**Re: Griegos Farm/ 4560 Guadalupe Church Rd. NW PHASE 5
Request for Certificate of Occupancy
Transportation Development Final Inspection**
Architect's Stamp dated 06-14-22 (F13-D028A)
Certification dated 10-29-25
TRANS# 2025-00320

Project: GRIEGOS FARMS
 Drawn By: KMA Checked By: KMA
 Date: ---
 Drawing Title: TCL- TRAFFIC CONTROL LAYOUT SITE PLAN

TCL1

A1 SITE PLAN

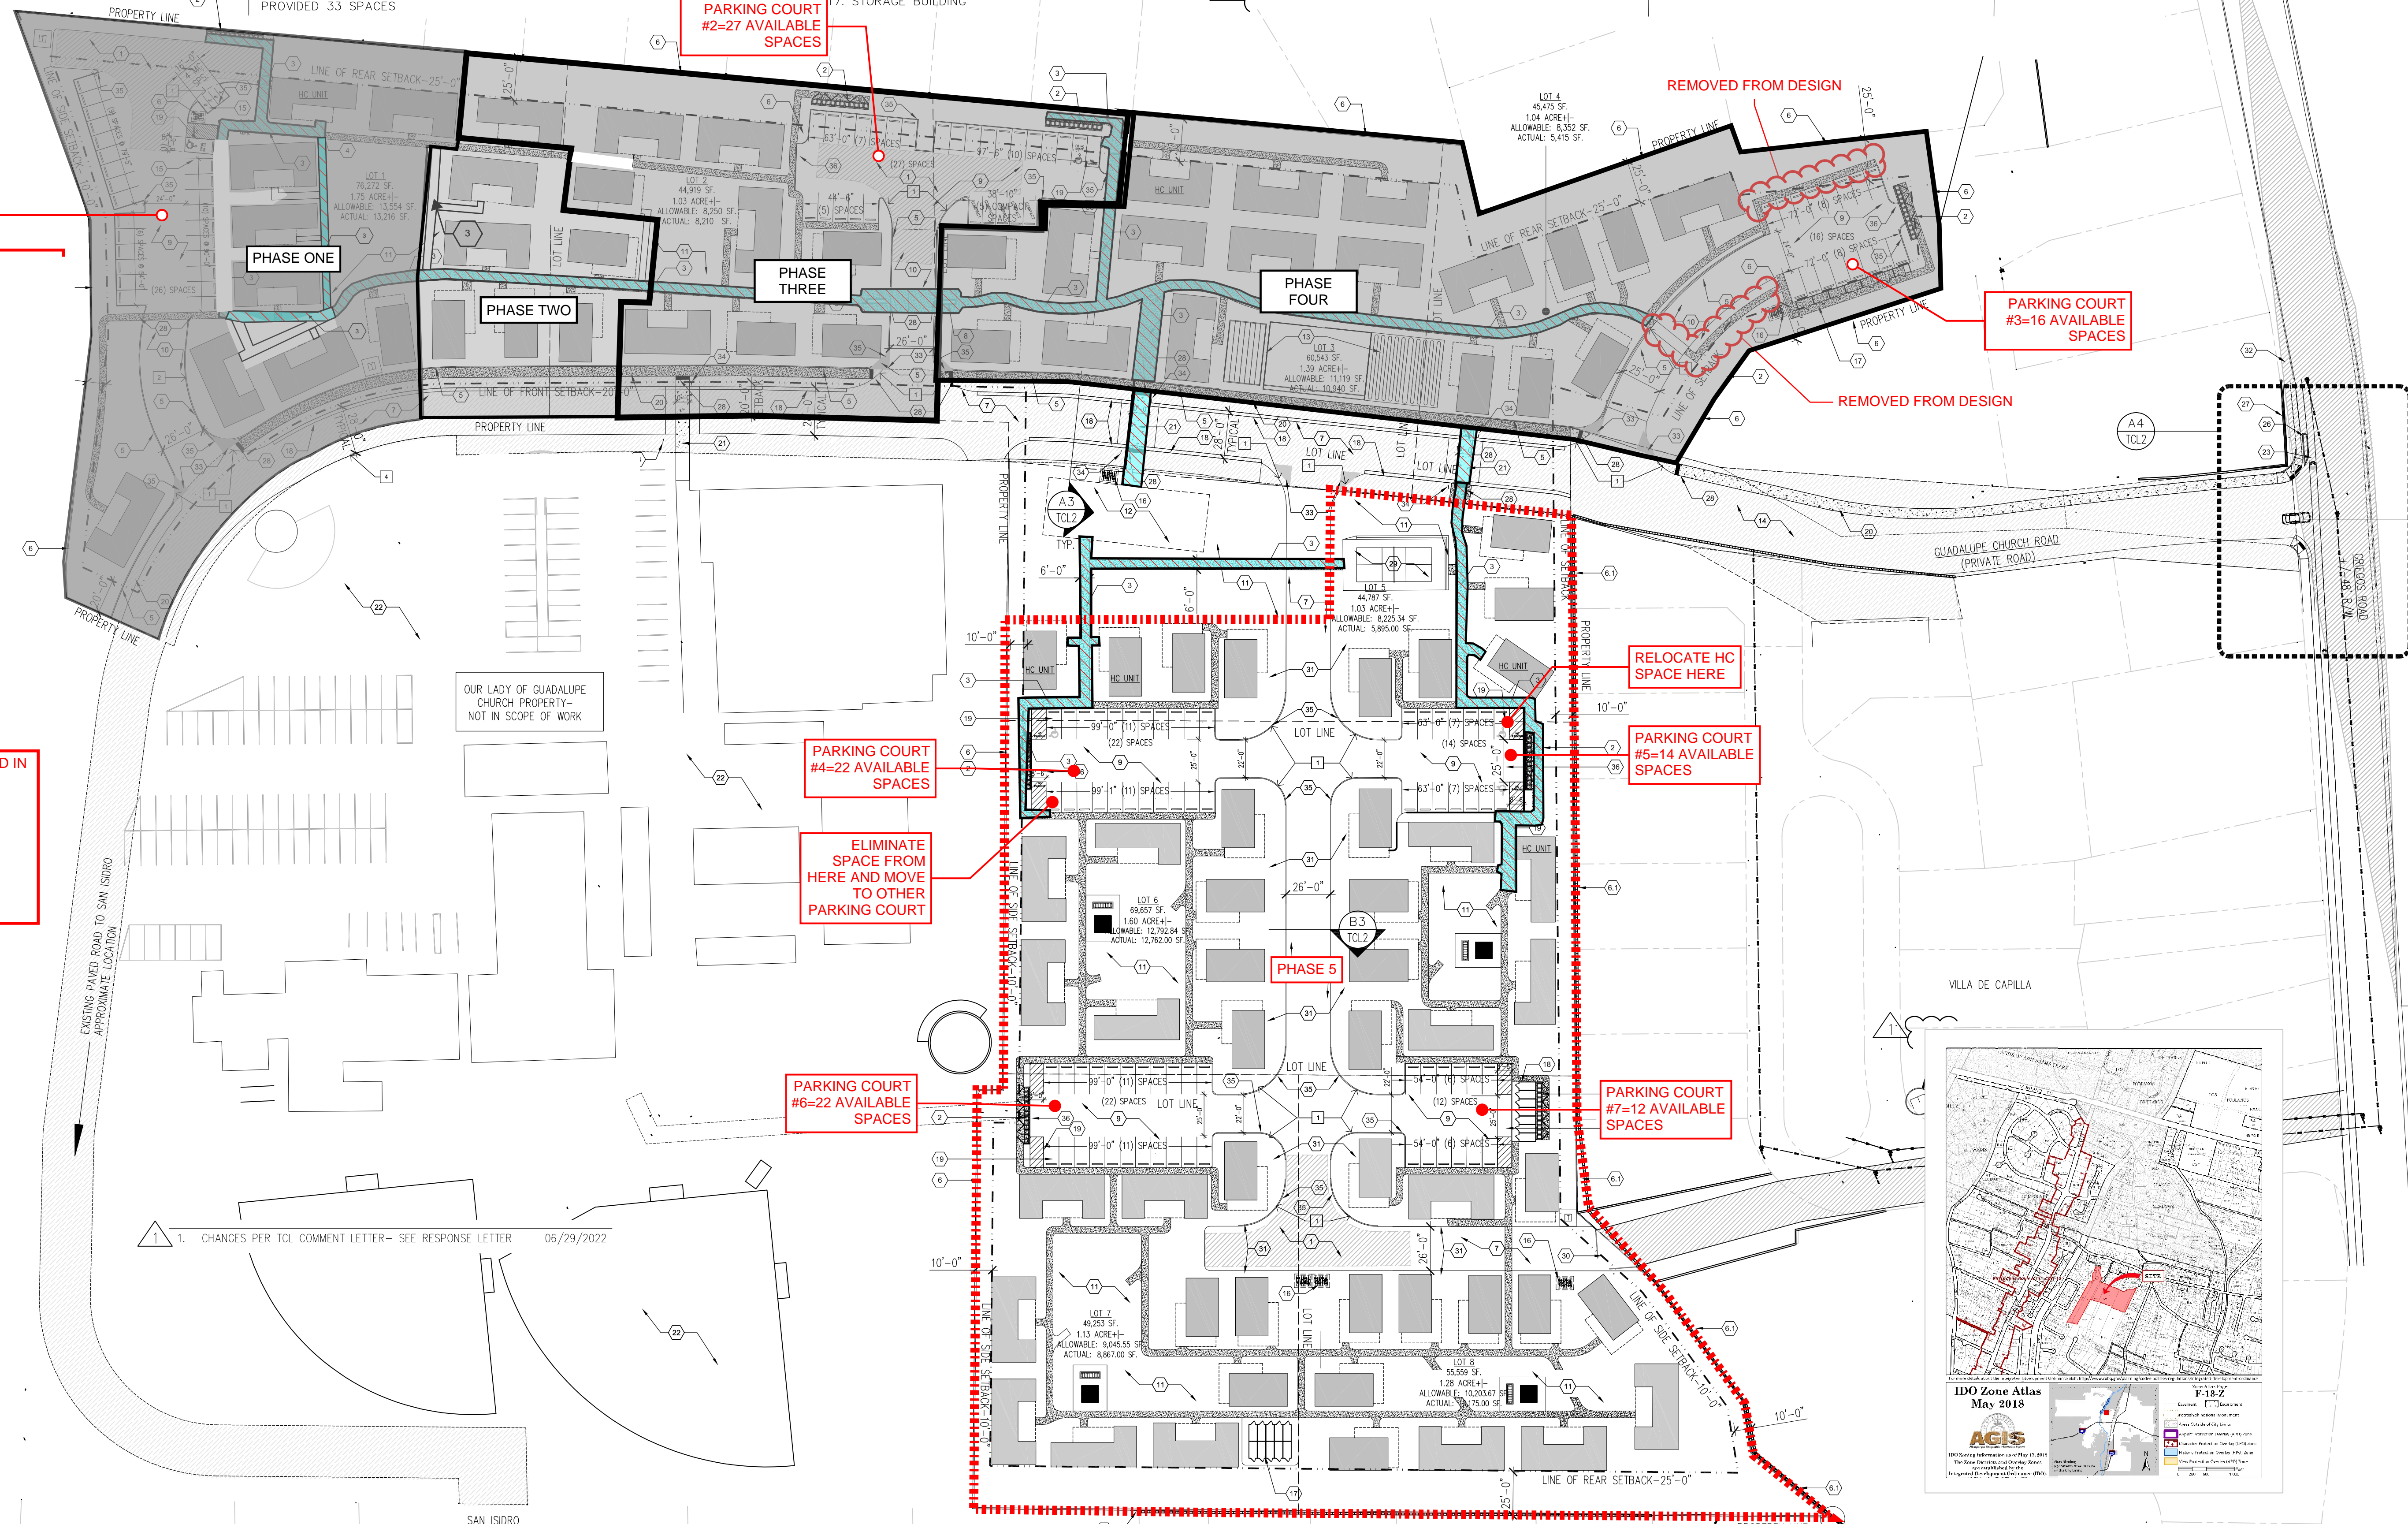
ELIMINATE SPACE FROM HERE AND MOVE TO OTHER PARKING COURT

RELOCATE HC SPACE HERE
